SERVICE NO. 1342 BULLETIN

Date: January 24, 2020

STABILATOR FITTING INSPECTION

Figure 1, Sheet 2 of 3
Stabilator Attach Fitting Assemblies

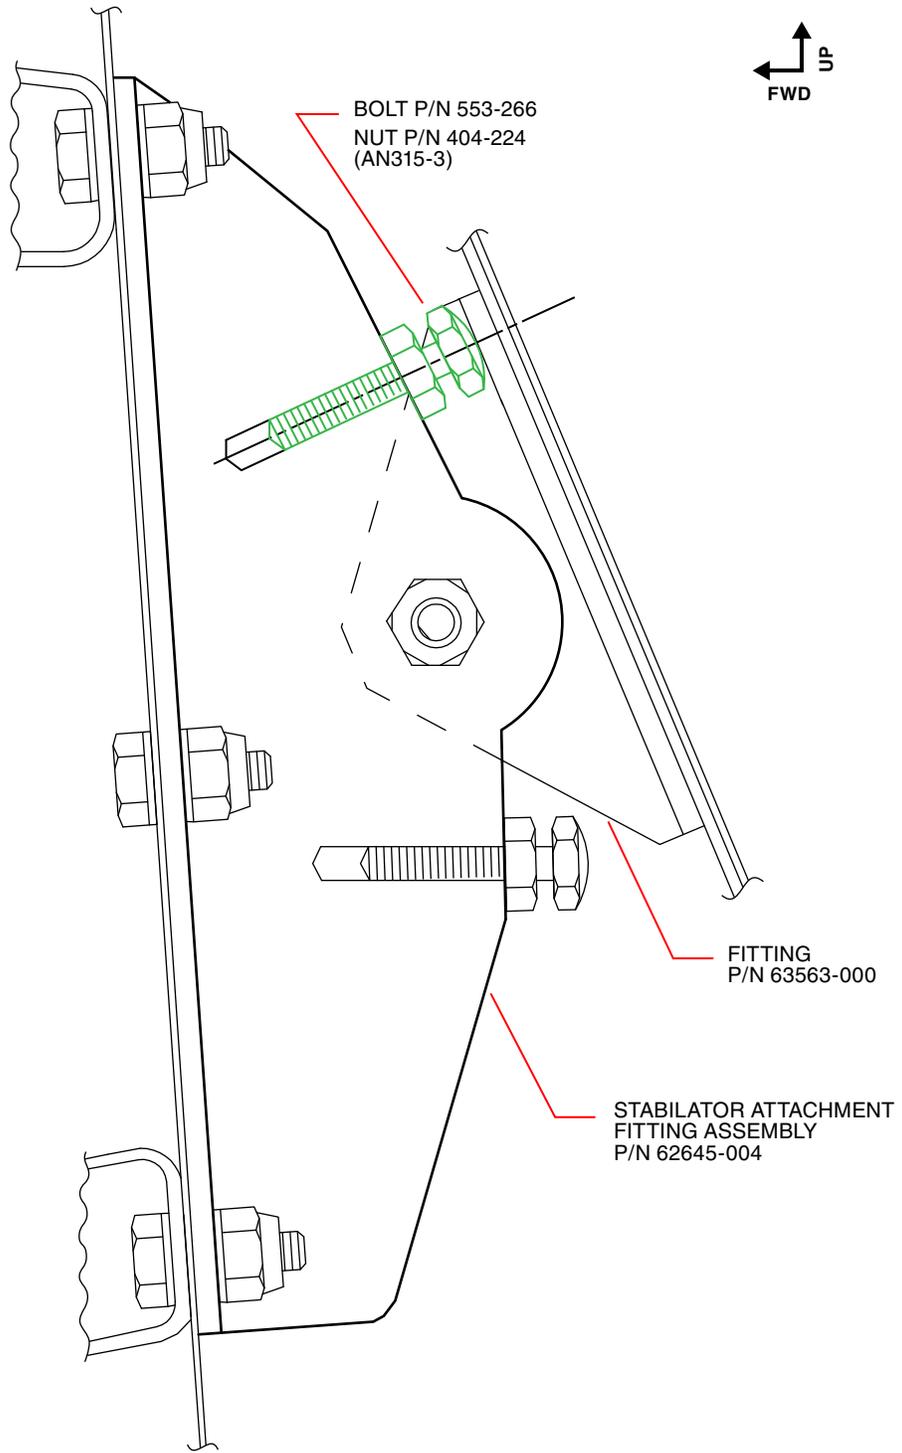
VIEW B-B
CONFORMING
STABILATOR ATTACHMENT FITTING INSTALLATION
(NO REPLACEMENT IS REQUIRED)

Figure 1, Sheet 3 of 3
Stabilator Attach Fitting Assemblies

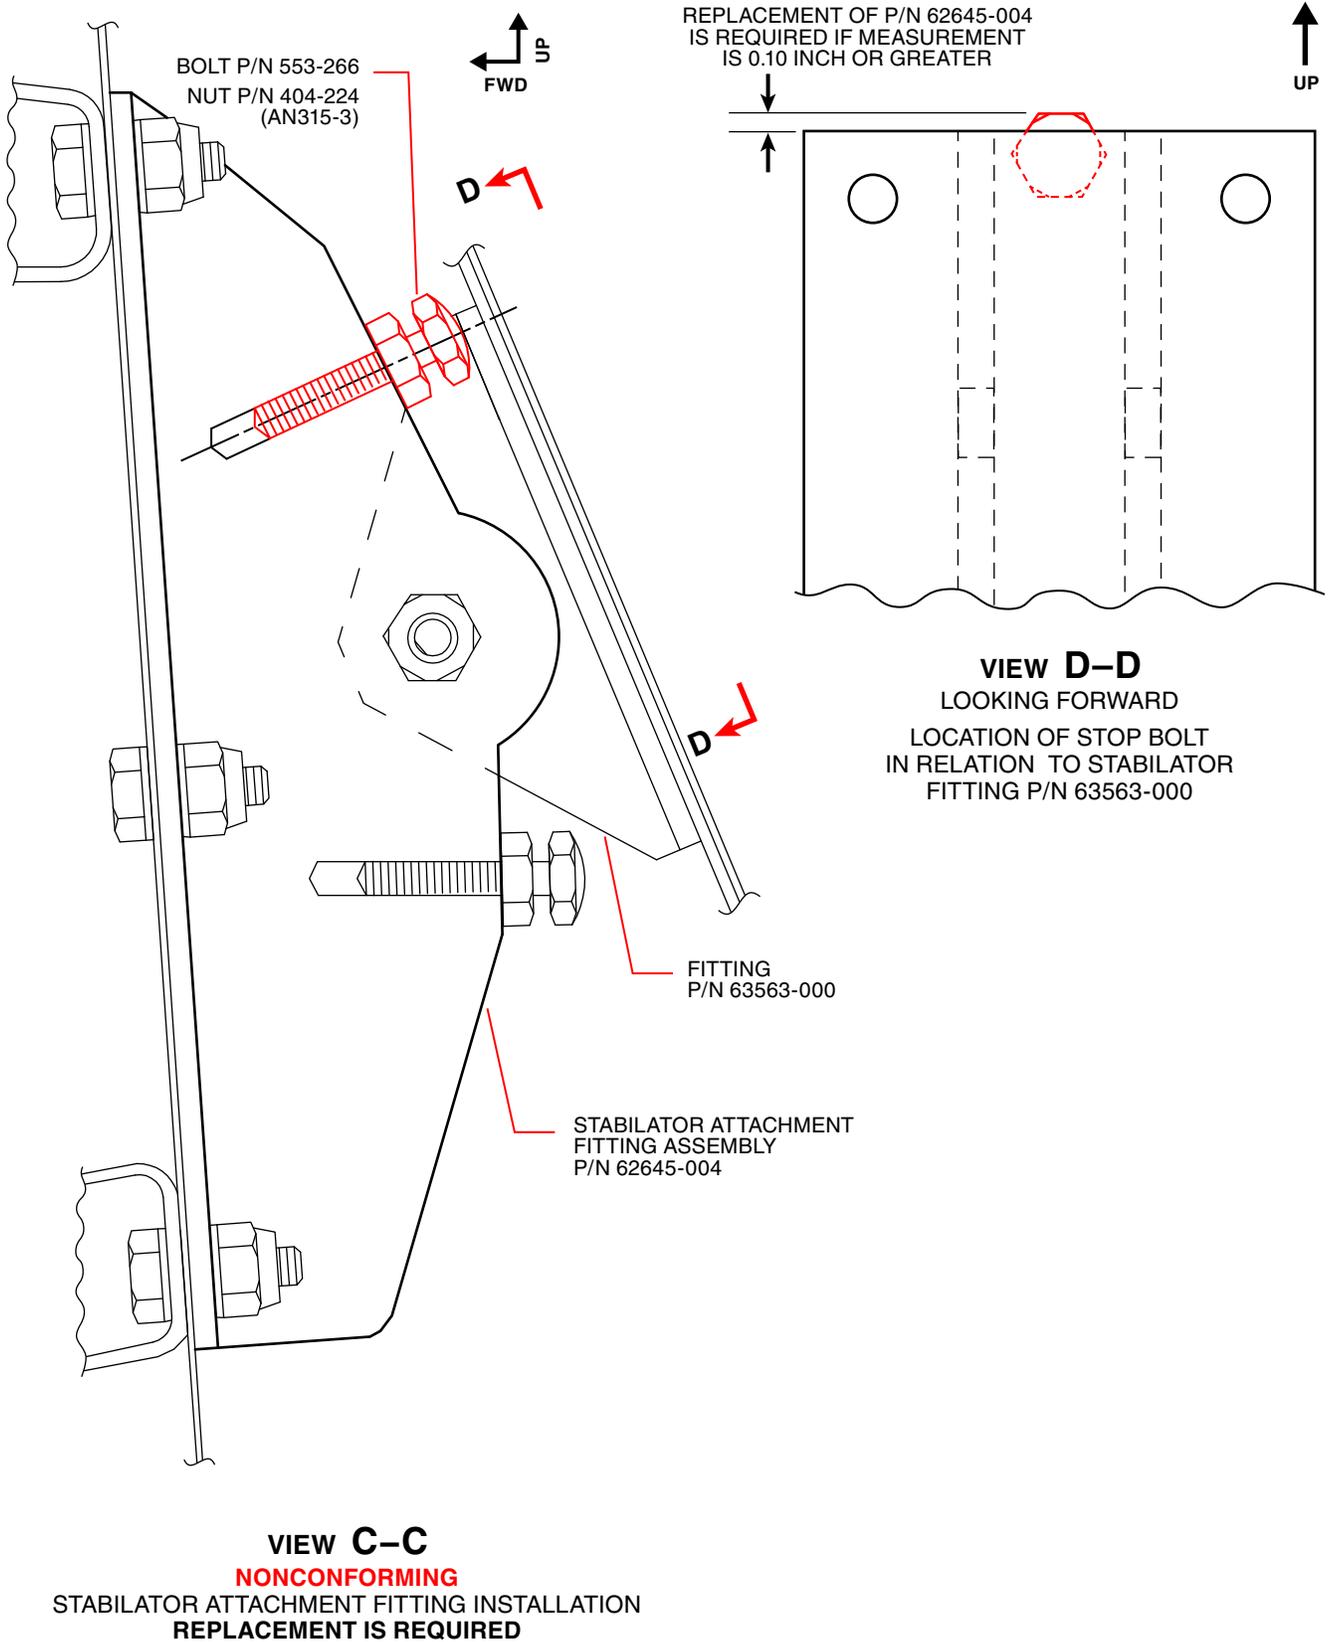
1. Take the following action, depending upon model group:
 - For airplanes listed in Group A, proceed to Step 2.
 - For airplanes listed in Group B, examine maintenance records to determine if any replacement Stabilator Attachment Fitting Assembly, Piper part number (P/N) 62645-004 was ordered between April 17 and July 30, 2019, and installed on the aircraft.
 - If so, or if maintenance records for the specified time frame are not available, proceed to Step 2.
 - If not, proceed to Step 6.
2. Gain visual access to both Stabilator Attachment Fitting Assemblies, Piper P/N 62645-004.
3. Compare the installed configuration to Figure 1, Views B–B and C–C.

If the Bolt, P/N 553-266, protrudes past the edge of the Fitting, P/N 63563-000, as shown in View C–C, then measure the distance from the edge of the fitting to the outermost portion of the bolt, as shown in View D–D.

- **Does not conform to type design:** If the measured distance, per View D–D, is 0.10 inch or greater, then the Stabilator Attachment Fitting Assembly, P/N 62645-004, must be replaced. Proceed to Step 4.

- **Conforms to type design:** Any fitting that matches View B–B conforms to type design, so replacement is not required. If the measured distance, per View D–D, is less than 0.10 inch, then replacement is not required. Proceed to Step 6.
